Re: SO₂ Area Designation for Labadie Energy Center

Re: Comments on Ameren Missouri's Labadie Sulfur Reduction Project Quality Assurance Project Plan

Re: 2015 Monitoring Network Plan

Figure 6. Appropriately located Rush Island monitors (three monitor configuration).

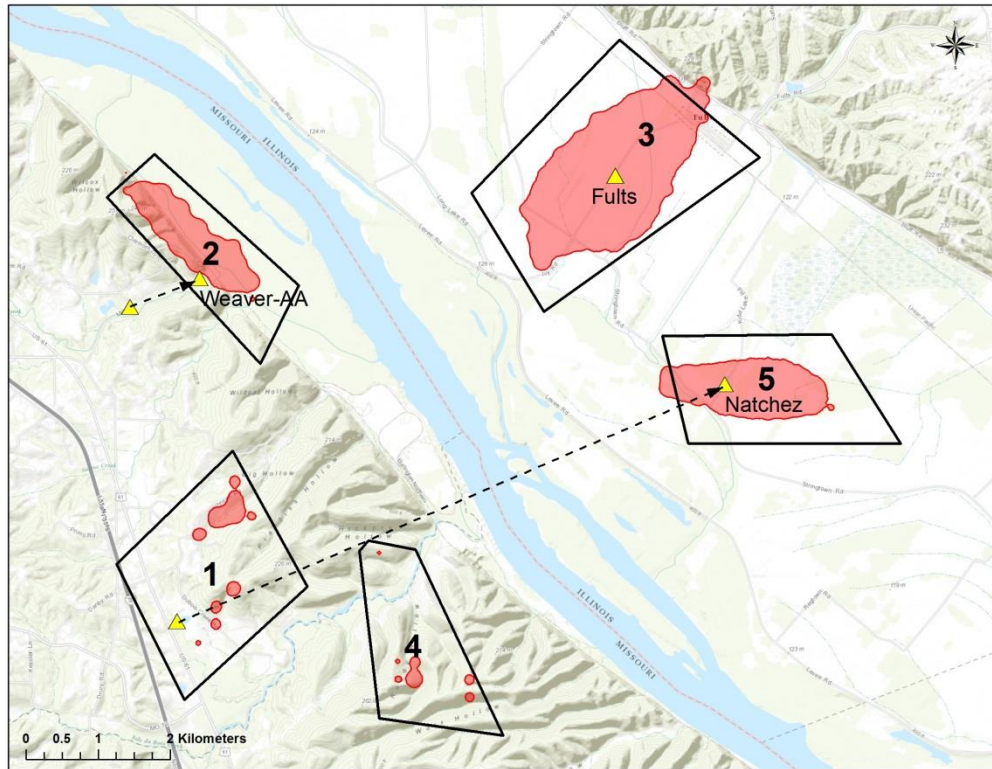
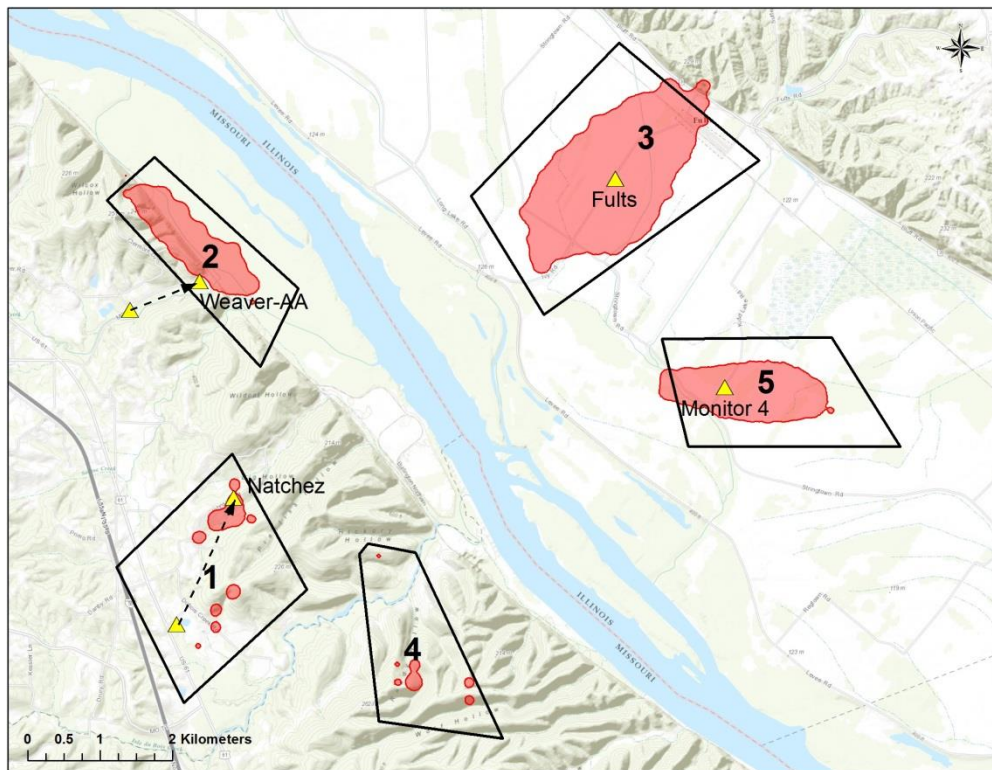
Because they are not properly located, neither the Natchez nor Weaver-AA monitoring sites will adequately represent Rush Island's SO₂ air quality impact. Therefore, both sites should be relocated. The Weaver-AA site should be located inside the peak concentration area within polygon 2 and the Natchez site should be located inside the peak concentration area within polygon 5 as shown in Figure 6 below. Alternatively, the Natchez site could be moved inside the peak concentration area within polygon 1 and a fourth monitor added inside the peak concentration area within polygon 5 as shown in Figure 7 below. The recommended monitor locations shown in Figures 6 and 7 are easily accessible and appear to meet EPA siting criteria and have ready access to power.

Figure 1. Modeled SO₂ design values in the vicinity of the Rush Island Energy Center.

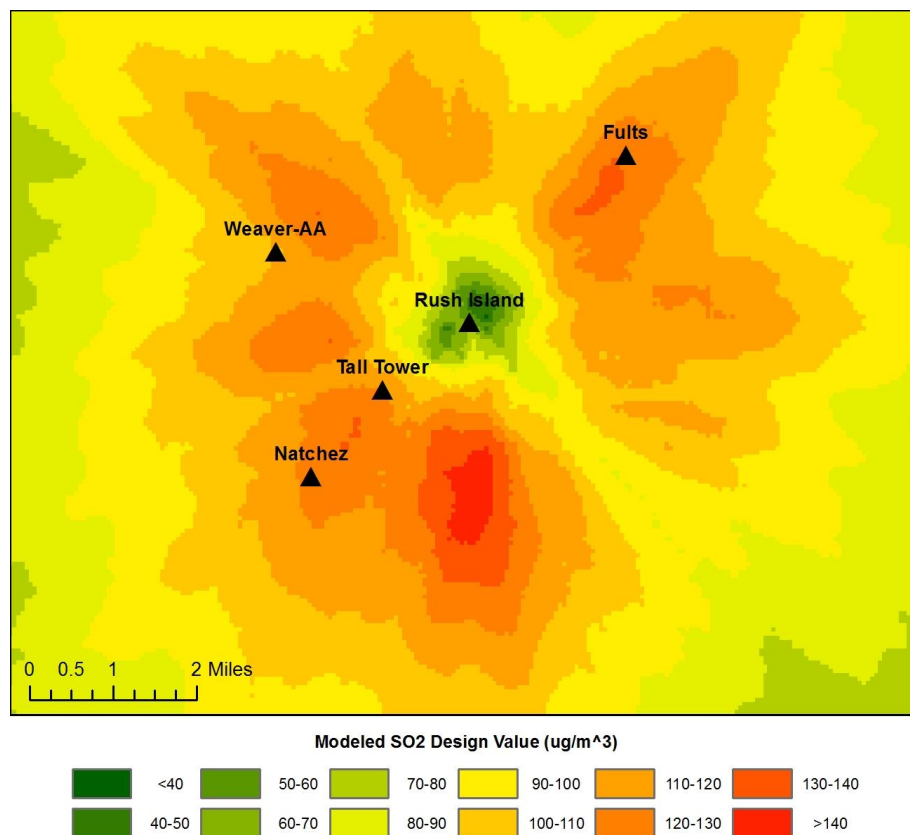
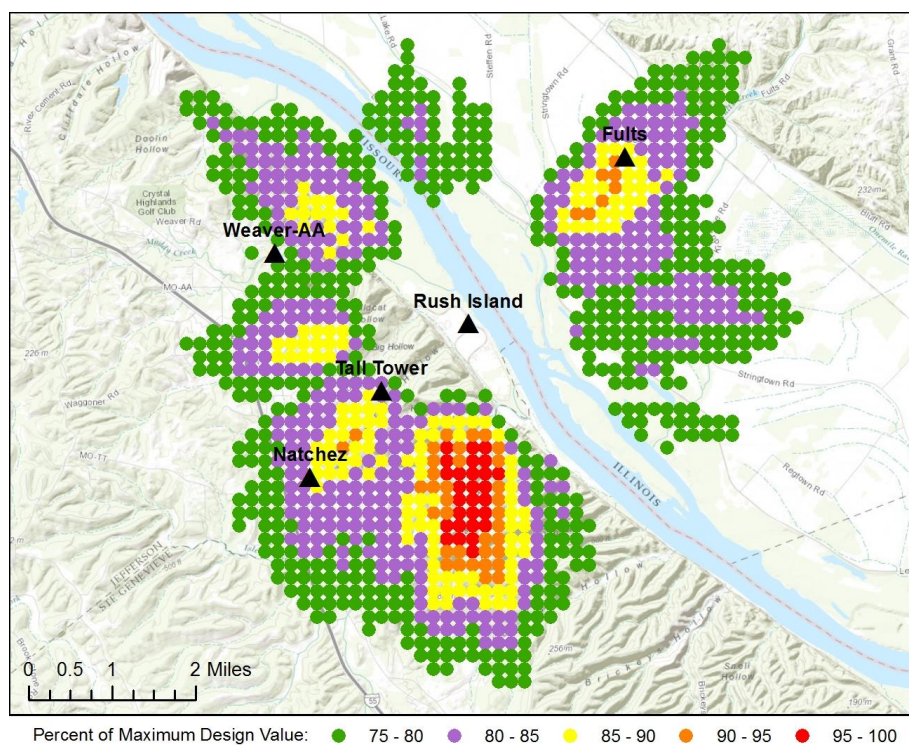
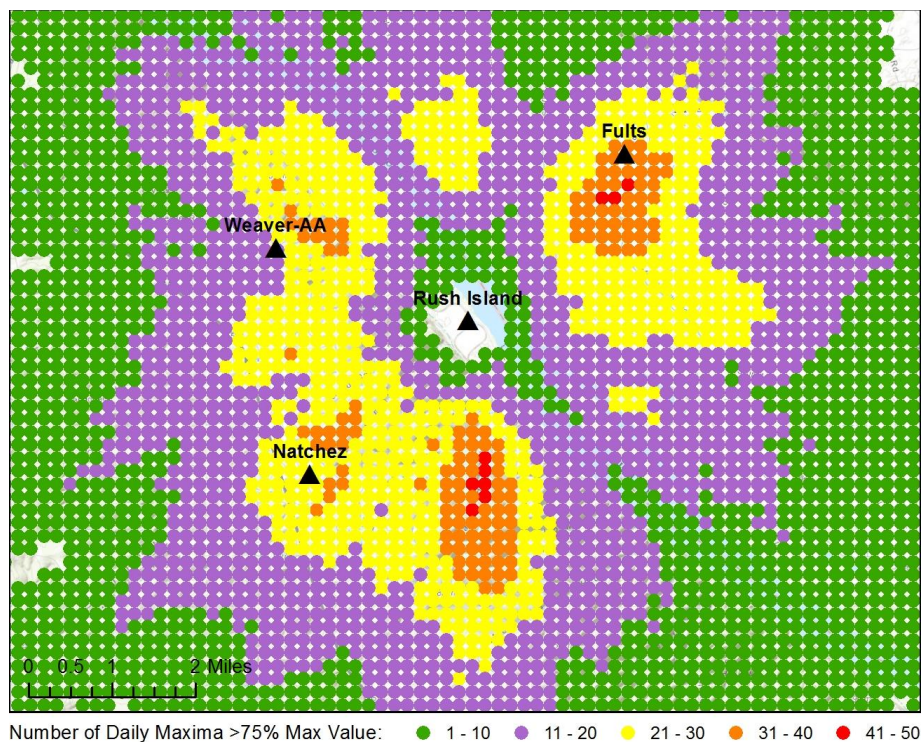
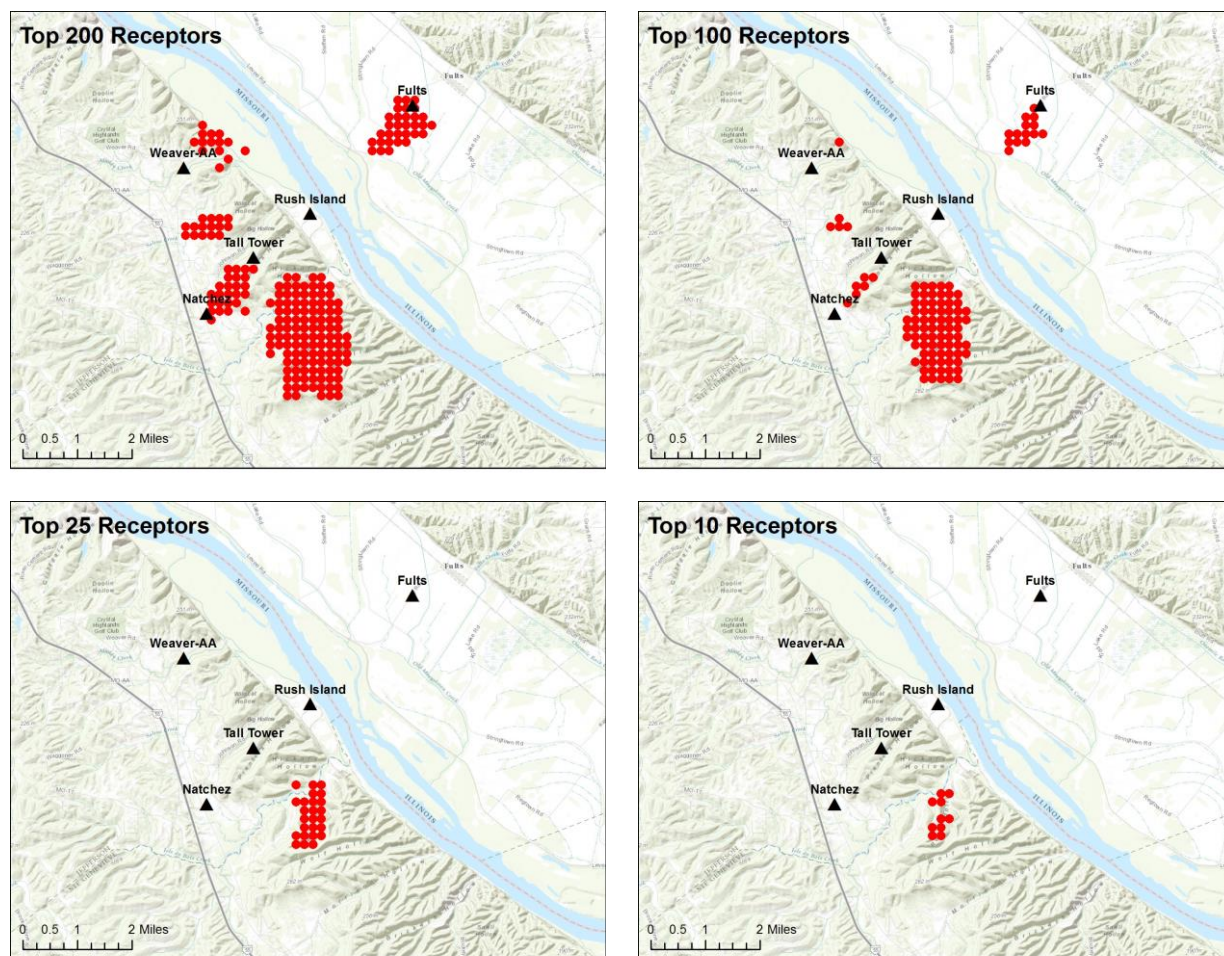
Figures 1 through 4 below show the results of Ameren’s modeling, which we derived using model input files provided by DNR. Figure 1 shows modeled SO₂ design values in the vicinity of the plant; Figure 2 shows receptors with modeled design values greater than or equal to 75 percent of the maximum modeled design value (146.1 ug/m³); Figure 3 shows the number of times the model-derived maximum daily 1-hour concentration exceeded 75 percent of the maximum modeled design value at each receptor; and Figure 4 shows the receptors with the top 200, 100, 25, and 10 modeled design values. The locations of the plant and the proposed Fults, Natchez, and Weaver-AA SO₂ monitoring stations and the proposed Tall Tower meteorological monitoring station are shown on all figures for reference.

Figures 1 through 4 all reveal a strikingly similar pattern regarding the areas where peak 1-hour SO_2 concentrations are expected to occur around the Rush Island Energy Center. There is a large area due south of the plant where modeled design values are the highest (in excess of 95 percent of the maximum modeled design value), where modeled maximum daily 1-hour concentrations frequently exceeded 75 percent of the maximum modeled design value, and where over half of the top 200 receptors (including all of the top 25 and three quarters of the top 100) are located. There are also four other areas where modeled design values are slightly lower but still very high (in excess of 85 percent of the maximum modeled design value), where modeled maximum daily 1-hour concentrations frequently exceeded 75 percent of the maximum modeled design value, and where the rest of the top 200 receptors are located. These four areas, located northeast, northwest, west, and southwest of the plant, plus the area south of the plant where modeled design values are the highest, are where Ameren's modeling predicts peak 1-hour SO_2 concentrations are expected to occur. Monitoring stations located in these areas would have the greatest chance of identifying peak SO_2 concentrations in ambient air, which is the primary objective of source-oriented monitoring and an absolute necessity when monitoring to assess

Figure 5. Modeled design values, receptors with design values ≥ 75 percent of the maximum modeled design value, and proposed monitoring station locations.

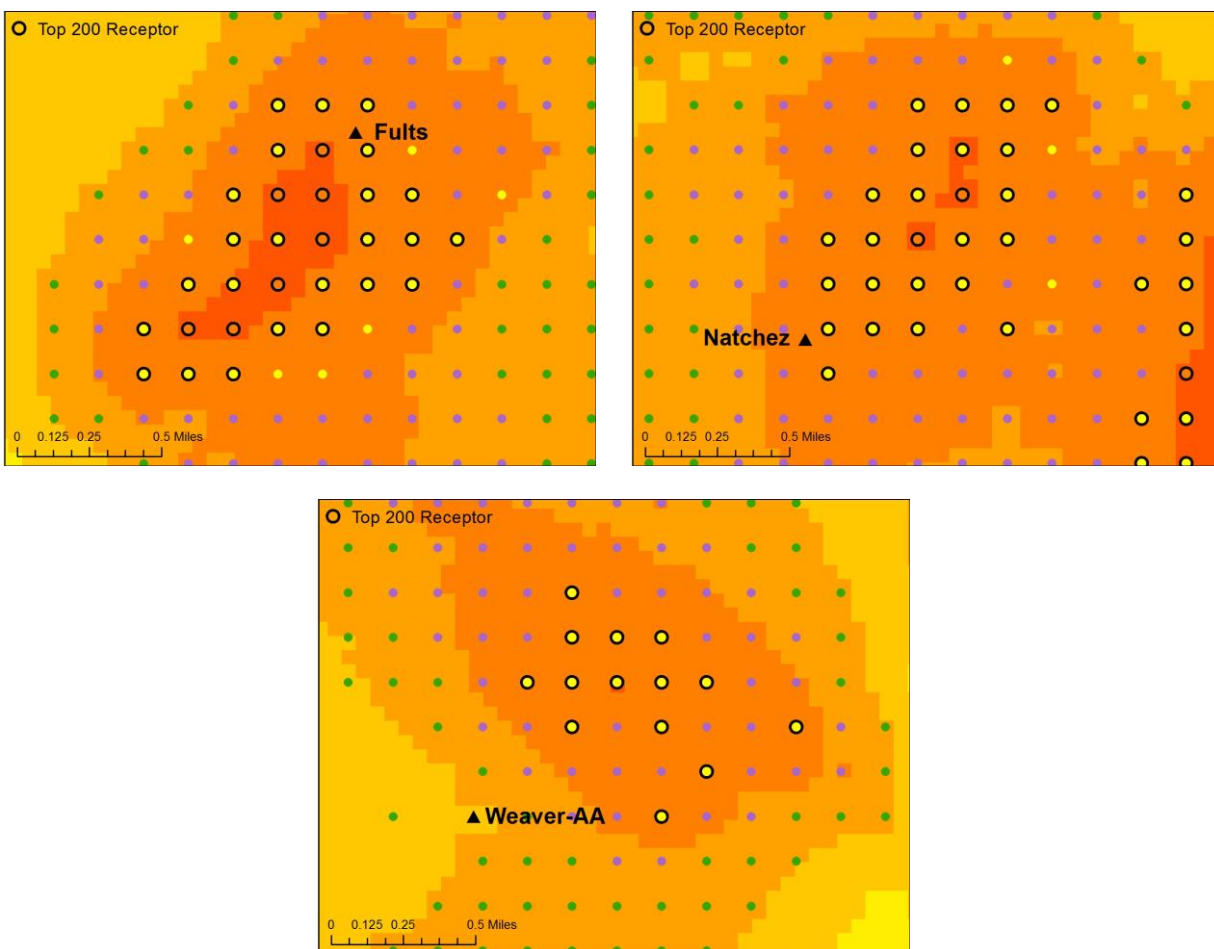
Furthermore, two of the proposed monitoring stations – Fults and Natchez – are located near but outside of areas of modeled peak concentration/high frequency instead of near the center of such areas, where concentrations are expected to be higher. The third proposed station – Weaver-AA – is located entirely outside of modeled peak concentration/high frequency areas. Figure 5 shows the locations of the proposed monitoring stations on a hybrid basemap comprised of Figures 1 (modeled design values) and 2 (receptors with modeled design values ≥ 75 percent of the maximum design value). Receptors that are among the 200 with the highest modeled design values are outlined for reference. All three monitoring stations could easily be sited in areas where higher 1-hour SO₂ concentrations are expected to occur with greater frequency, thereby increasing their chances of detecting any NAAQS exceedances that might occur around the Rush Island Energy Center. As discussed below, we urge DNR to consider these proposed optimized locations in lieu of Ameren's proposed Fults, Natchez, and Weaver-AA locations.

Fults – Of the three proposed monitoring stations, the Fults monitoring station is closest to an area where peak 1-hour SO₂ concentrations are expected to occur. However, moving the monitor less than one kilometer southwest of its current location would move it from an area with modeled design values in the 120-130 ug/m³ range to an area with modeled design values in the 130-140 ug/m³ range and place it near the center of a small group of receptors with modeled design values equal to 90-95 percent of the maximum modeled design value (the receptors

surrounding its current location generally have modeled design values equal to 85-90 percent of the maximum modeled design value). The entire area is floodplain/agricultural and Ivy Road, oriented northeast-southwest, runs through the middle of it, making the proposed optimized location as accessible as Ameren's proposed location and equally easy to provide power to.

Figure 6. Current and optimized locations of the Fults, Natchez, and Weaver-AA monitoring stations

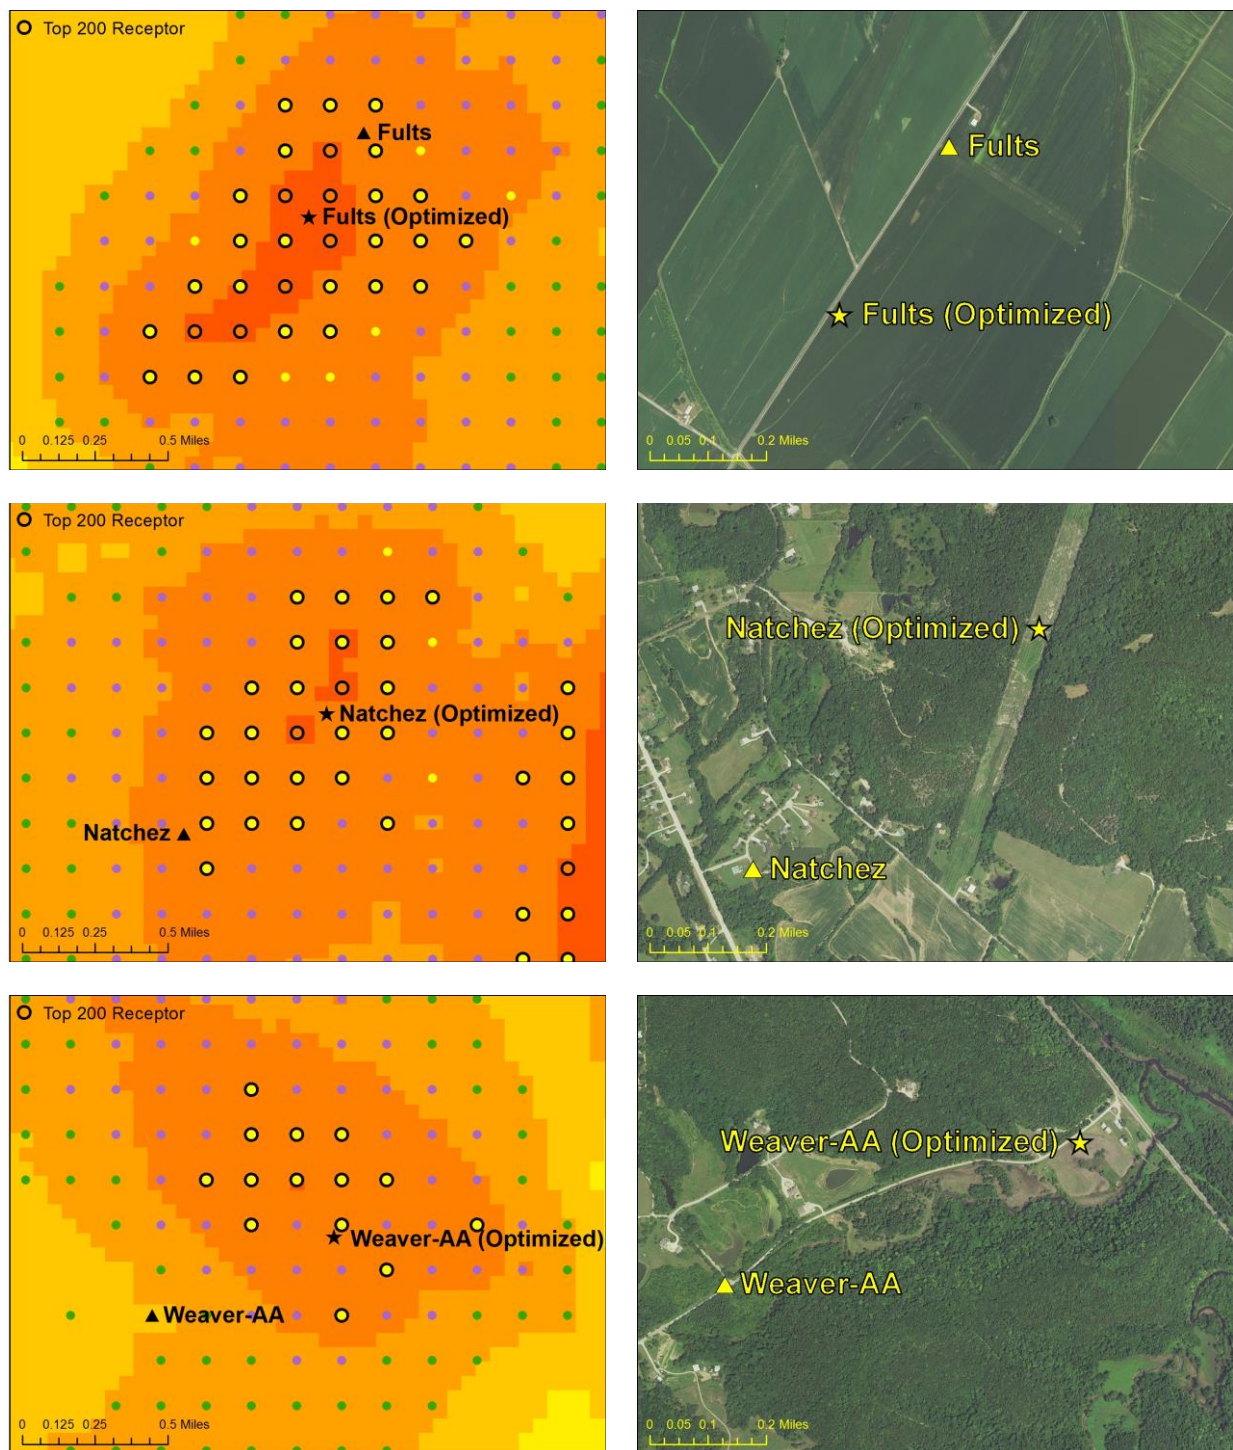
Figure 6 compares the locations of Ameren's proposed Fults, Natchez, and Weaver-AA monitoring stations with optimized locations more likely to record maximum SO₂ concentrations in the area.

We urge DNR to reject the proposed monitoring sites and require Ameren to add a monitoring station in the highest concentration area due south of the plant as well as to relocate the proposed Fults, Natchez, and Weaver-AA monitoring stations to the optimized locations shown in Figure 5. We also urge DNR to require Ameren to 1) rerun the air dispersion model described in the report using Rush Island's actual hourly emissions; 2) evaluate the effects of nearby interactive sources (including, at a minimum, River Cement, St. Gobain Containers, Holcim, Mississippi Lime, Dynegy's Baldwin Energy Complex, and Ameren's Meramec Energy Center) on modeled peak concentration/high frequency areas; and 3) evaluate the appropriateness of using meteorological data from the Cahokia, Illinois airport instead of Doe Run Herculanum given DNR's determination that the latter is more representative of the modeled area.⁷ We further urge DNR to require any necessary adjustments to the proposed monitoring network based on the results of these analyses.

Figure 1. Expected peak SO₂ concentration areas per Ameren’s modeling.

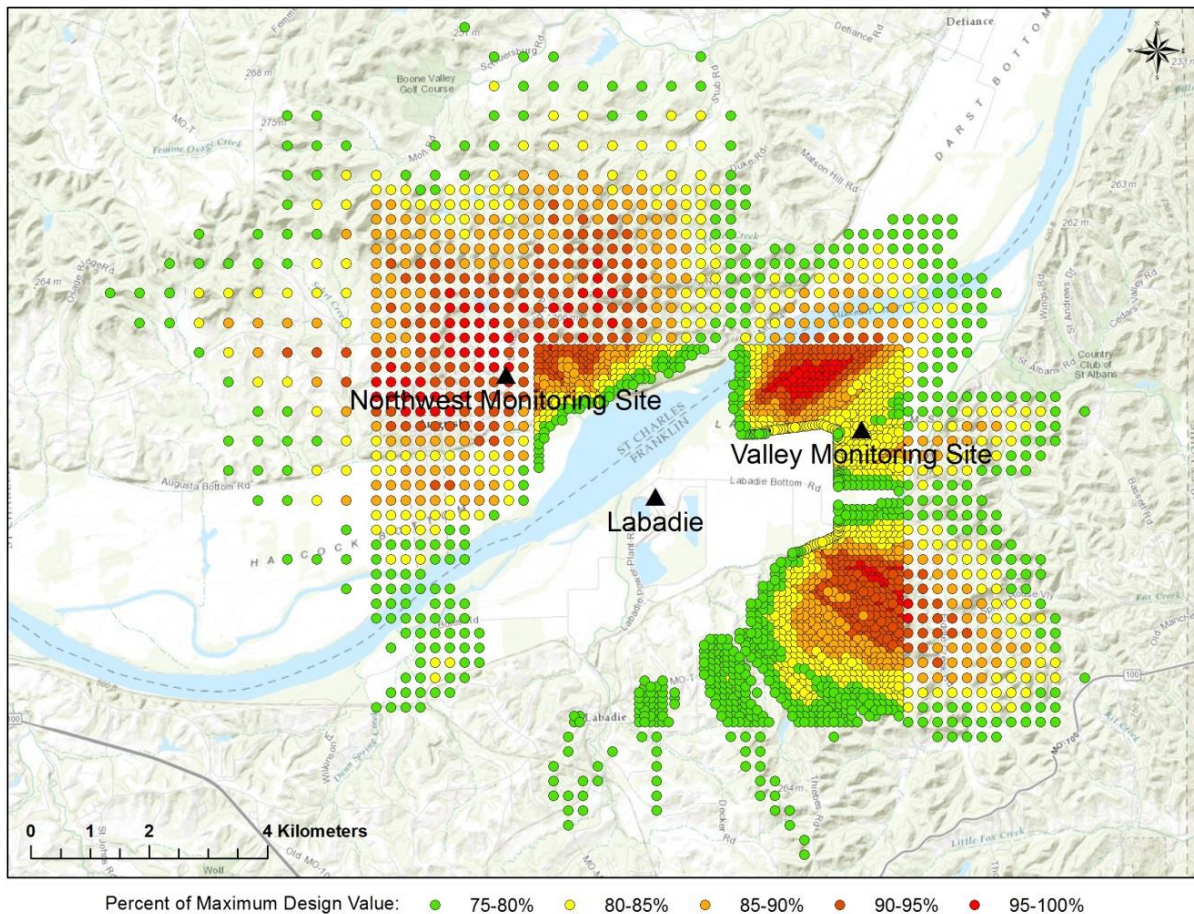
identified three distinct areas where peak SO₂ concentrations are expected to occur. These areas, demarcated by orange and red receptors, are located northwest, northeast, and southeast of the plant and are shown in Figure 1 below. However, only one of the two new monitoring sites – the Northwest site – is located in a peak concentration area as modeled by Ameren. The Valley monitoring site is located between the other two Ameren-modeled peak concentration areas, in an area where the modeled concentration is only about 80 percent of the maximum concentration predicted by Ameren’s model.
